OSSA WEST

SERVICE BULLETIN #0-0-1

YANKEE MOTOR CORPORATION

OSSA SERVICE BULLETIN #2-4-2

250 PIONEER CARBURETOR

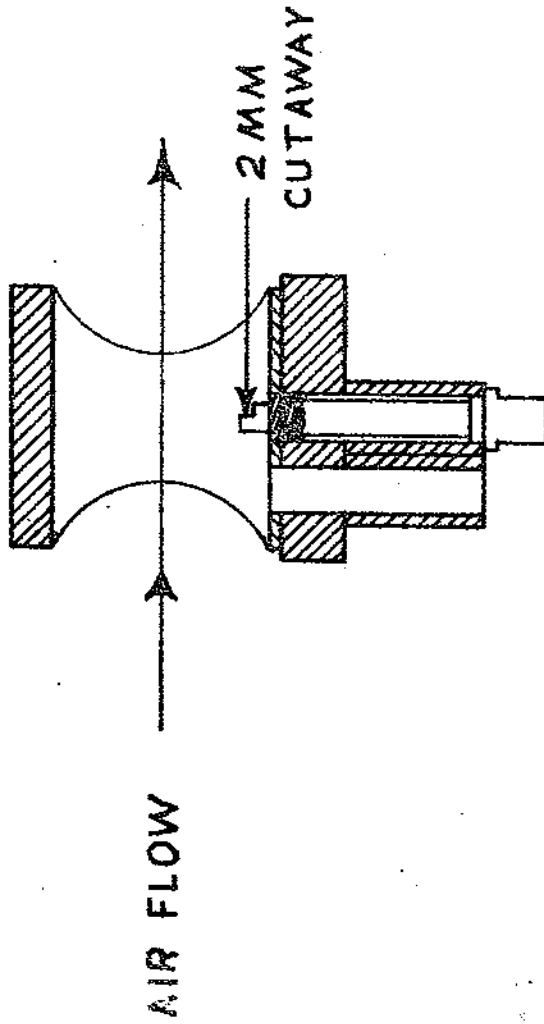
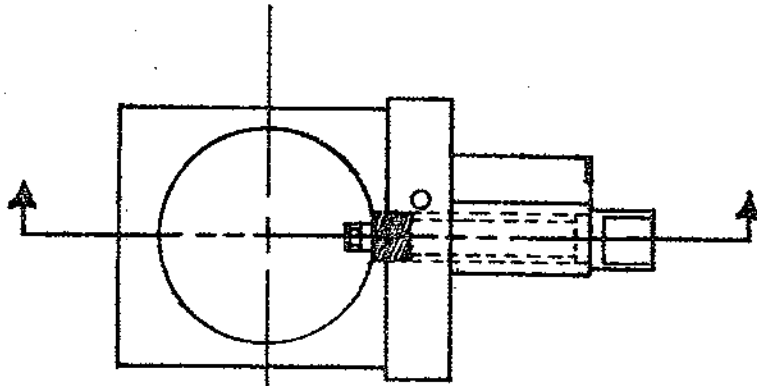
CORRECTION OF PRE-IGNITION

There have been several reports of the late model Pioneer making "detonating" or "pinging" noises at high speed or under a load. The solution involves cutting away the rear side (cylinder side) of the low speed emulsion tube (short needle jet). This improves the atomization (fuel-air mixture).

Since the emulsion tube screws in, it must first be marked on the vacuum side, or the side next to the cylinder, while still tight in the carburetor body. After the emulsion tube has been removed, cut away with a file or grinder, the marked half, 2 mm in depth.

The mid-range needle (long one) clip MUST be in the middle or top groove so the needle is down into the emulsion tube far enough that it can not come out. Each carburetor modified should be checked to see that the needle is not coming out of the emulsion tube.

CUSH DRIVE SPRINGS

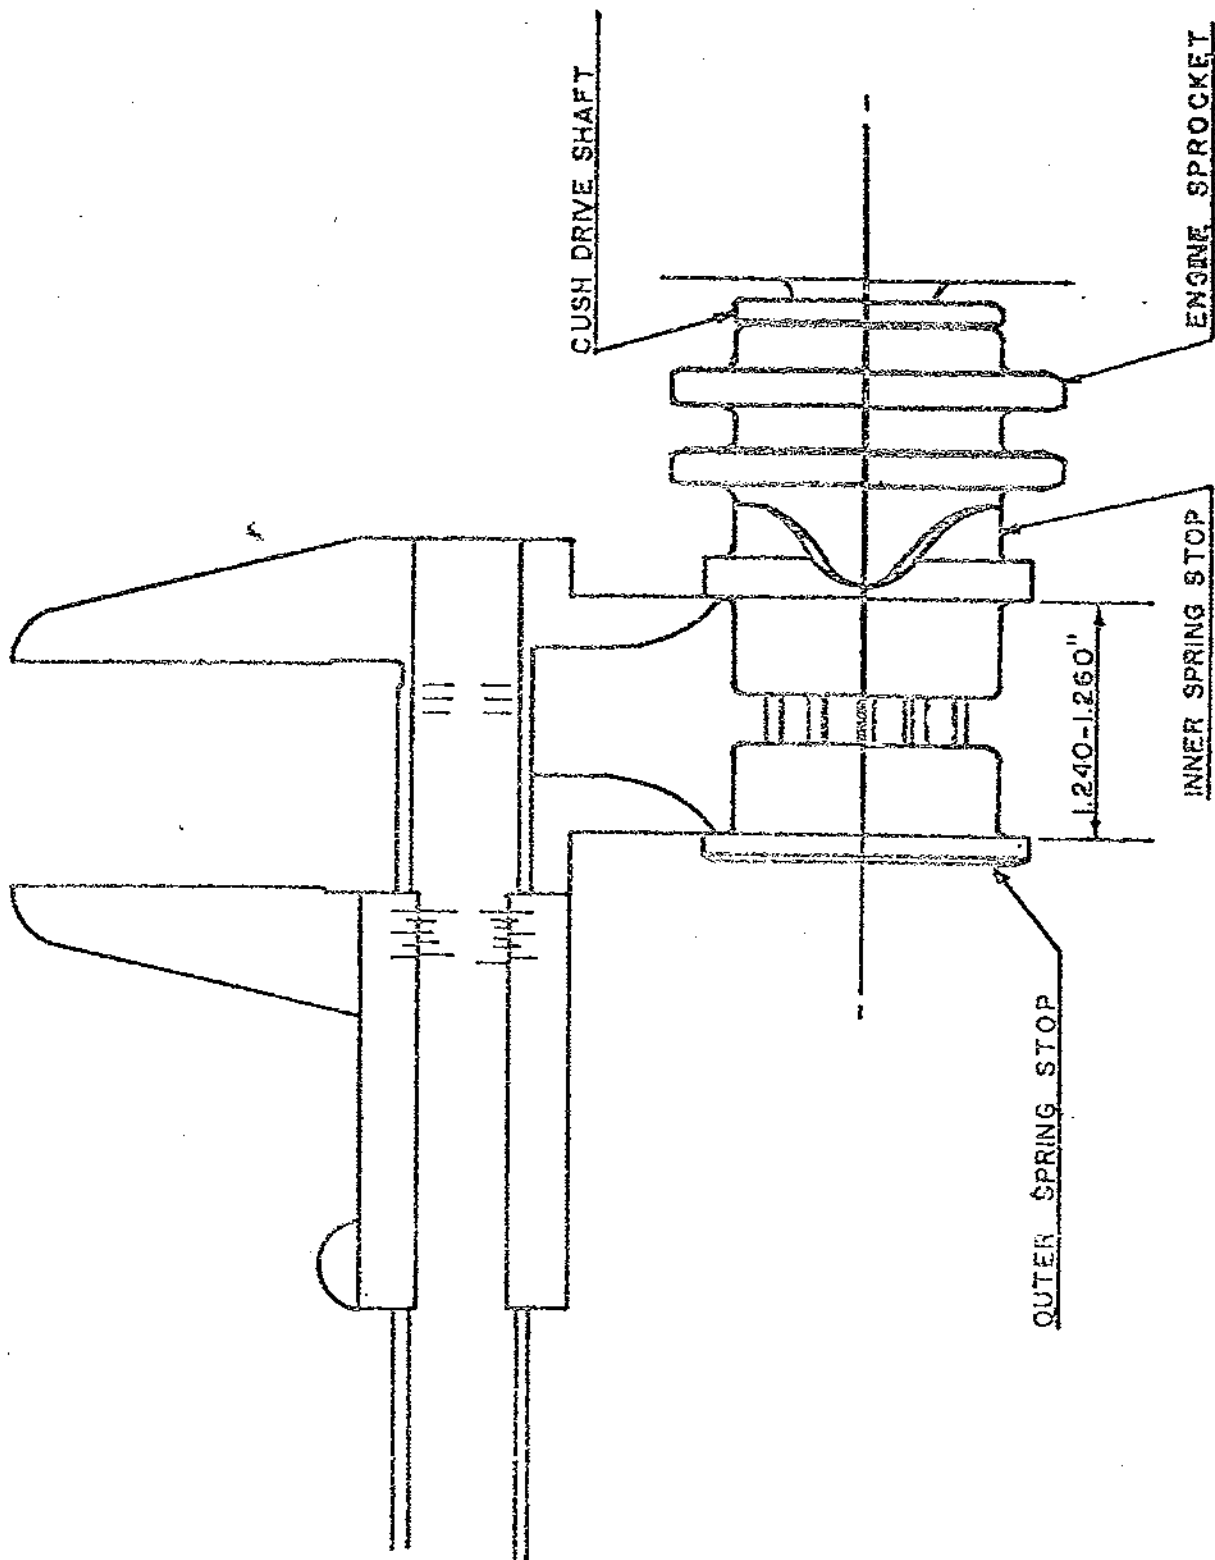
When reassembling the primary drive train of the OSSA engine, particular attention should be paid to the cush drive spring on the crankshaft. If frequent primary chain troubles are encountered, this spring could be the cause. Insufficient tension of this spring may result in premature chain wear or breakage. The methods for checking it are as follows:

1. Measure the relaxed height of the spring, using a caliper or height guage. It should measure no less than 1.4".

2. Assemble the cush drive components on the crankshaft, but leave out the spring. Tighten the 9 m/m allen nut. Once again, using the calipers, measure the distance between both spring seats as shown in the illustration. This distance should be  $1/250" \pm .010"$ . Put the spring on the tester and set the checking height of the tester to 1.250" or whatever your measurement was. It then should require at least 150 lbs. pressure to compress the spring to that height.

If the spring fails either of these tests, replace it. They are very inexpensive and could prevent subsequent difficulty later on. If your measurement of the distance between spring seats is in excess of 1.240" to 1.260", the outer spring stop may not be sliding far enough over the cush drive shaft. The splines on the outer spring stop should be flush with the end of the cush drive shaft. If any of these pieces prove defective, replace them.

DRAWING #5-1

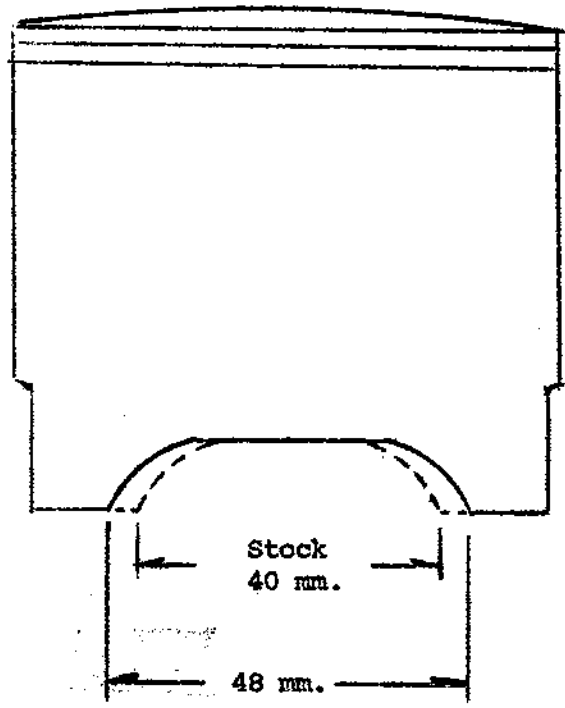
Port timing: The intake port should open 94° ABDC and the exhaust should open 84° ATDC as measured with a degree wheel attached to the magneto side crank. The new DMR piston part number will be 121-044 and should be modified per the drawing #5-1. A DMR piston is identified by its wall thickness which is no less than .120".

Reference: Port timing - A mistake was made in mentioning that the intake port should open at  $94^{\circ}$  ABDC - this is incorrect! The proper timing should be  $86^{\circ}$  After Bottom Dead Center (or expressed another way,  $266^{\circ}$  After Top Dead Center). The tolerance is plus or minus  $2^{\circ}$ . However, the engine runs best at precisely  $266^{\circ}$ ! Please remember that to adjust the port timing to the above "blue printed" specification, the inlet side of the piston skirt has to be scribed and then filed. Do not alter the inlet port of the cylinder liner just the piston skirt.

WIDEN CUTAWAY AS SHOWN AND DEBURR ALL EDGES

View Looking Into  
Venturi of Carburetor

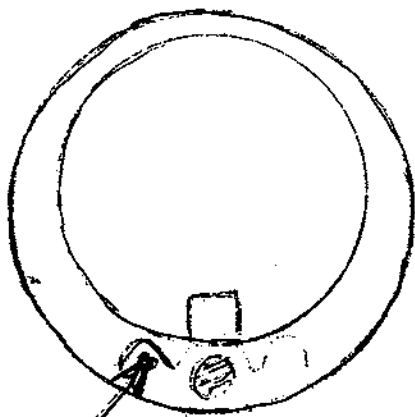
To increase low RPM performance and improve pulling power out of corners, we recommend the following modifications to be made to the 38 mm Bing carburetors installed on Ossa GP-II and GP-III Motocrossers.

Drill 1/16" hole thru  
to Pilot Air Screw hole.  
It is approx. 5/8" deep.

Set Screw Modification for Transmission Bearing

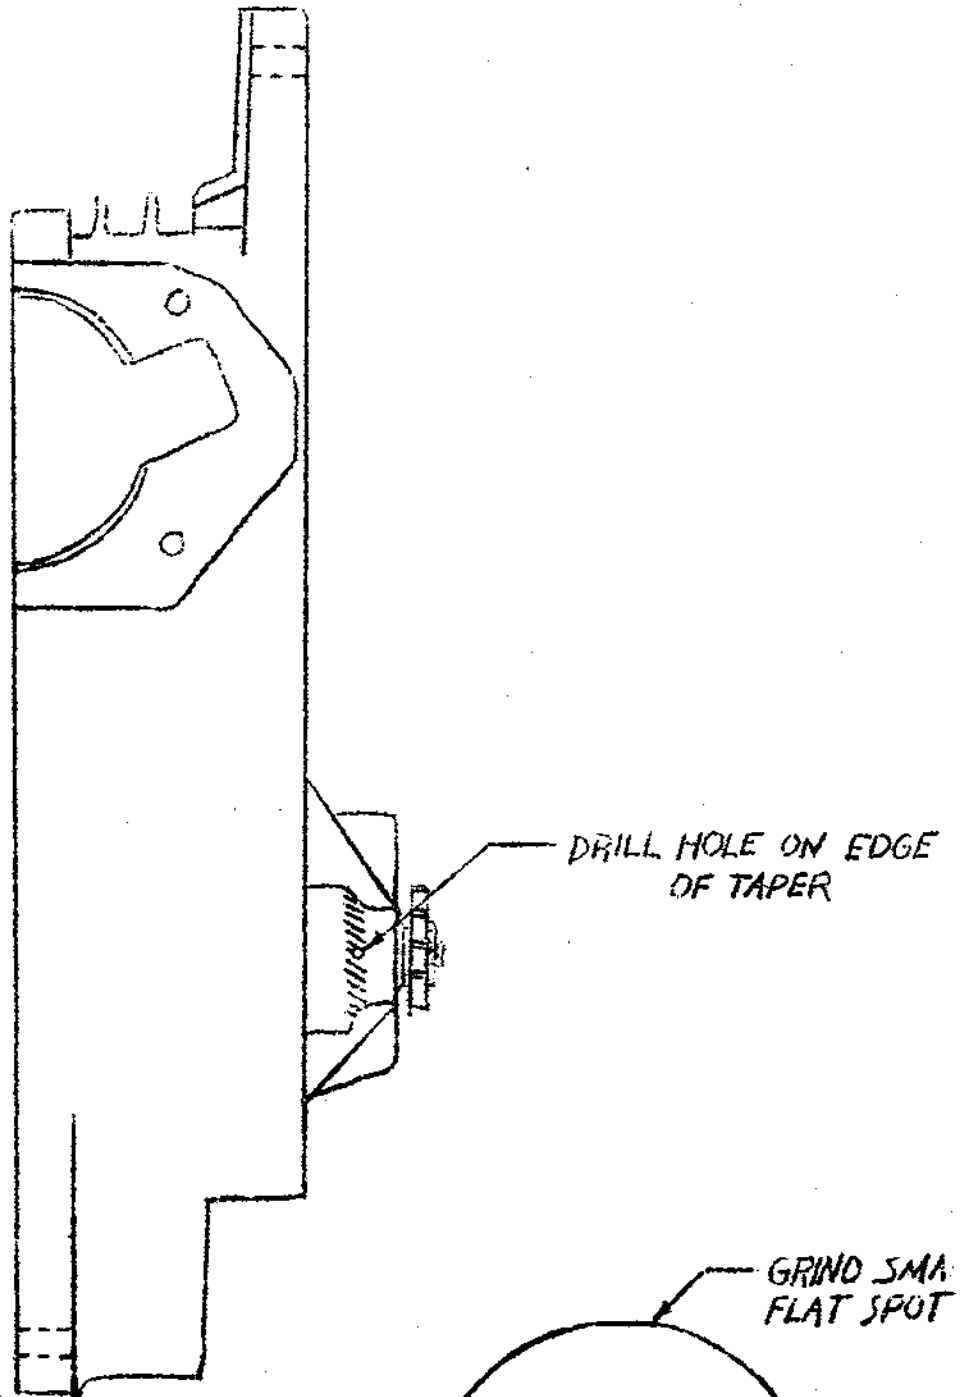
The following modification will prevent any further problem with transmission failures due to the right side transmission bearing working out of its seat. There has been known to be a lack of interference fit between the 5th gear bearing and the steel sleeve that fits in the right side of the center case. This can be attributed to repeated replacement of the particular bearing or lack of sufficient drive chain slack. In any event, there is an easy and inexpensive solution to the problem.

- 1) Dismantle engine and split cases.
- 2) Remove countershaft nut, washer, sprocket, bushing, and seal.
- 3) Slide the 5th gear out of the transmission bearing.
- 4) Press transmission bearing out of right side center case.
- 5) Using a center punch mark where hole is to be drilled (shown in diagram).
- 6) Drill a 13/16" hole and tap to 1/4 x 20 thread.
- 7) Grind small flat spot on top of bearing (as per diagram)
- 8) Scribe line on inside of center case showing where hole was drilled and taped.
- 9) Press bearing in place lining up flat spot with scribed line (flat spot must be in line with hole drilled).
- 10) Locktite 1/4 x 20 setscrew and bottom snugly against bearing surface.
- 11) Check bearing making sure it rotates freely.
- 12) Fill remaining hole with silicone sealant to ensure screw from backing out.
